464A - Piper

Piper Aircraft Corporation
Lock Haven, Pennsylvania, U.S.A.

Date:
March 22, 1976

SUBJECT:
Inspection of Stabilator Torque Tube Bearing Block Attachment Fitting Rivets.

SKETCH

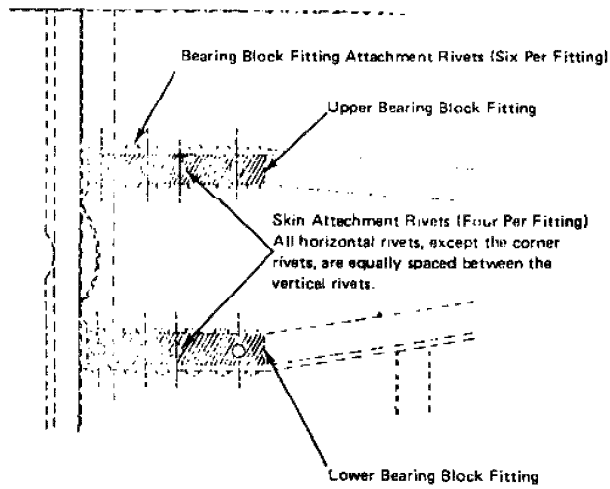
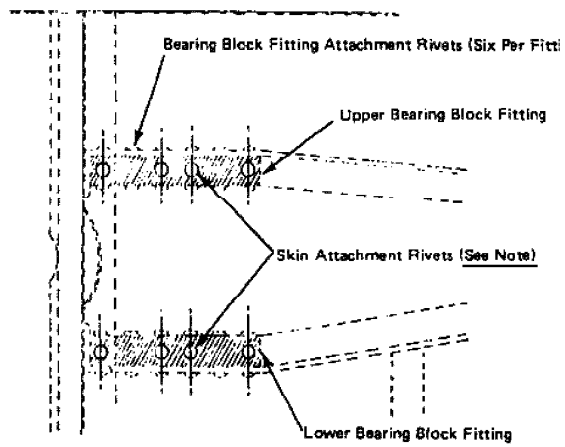
1. Remove the rear fuselage access panel located on the right side of the aircraft just forward of the stabilator.
2. Using a light and mirror (with extension), view through this access opening to determine if any of the horizontally positioned rivets through the skin align with any of the vertically positioned rivets in the bearing blocks (refer to sketch).

VIEW A-A: CORRECT RIVET ALIGNMENT

VIEW A-A: RIVET ALIGNMENT which may have resulted in rivet penetration:

NOTE: All horizontal rivets, except the corner rivets, are incorrectly installed in this view as they are aligned with the vertical rivets. If more than two rivet alignments are evident in each fitting, it will be necessary to install Kit 760 835.

3. If more than two (including the corner rivet) rivet alignments/penetrations in any bearing block fitting have been ascertained, installation of Kit Number 760 835 is required in the affected bearing block fitting. Two rivet alignments/penetrations or less as described in , paragraph 2. Purpose above, requires no further action except for the appropriate log book entry.
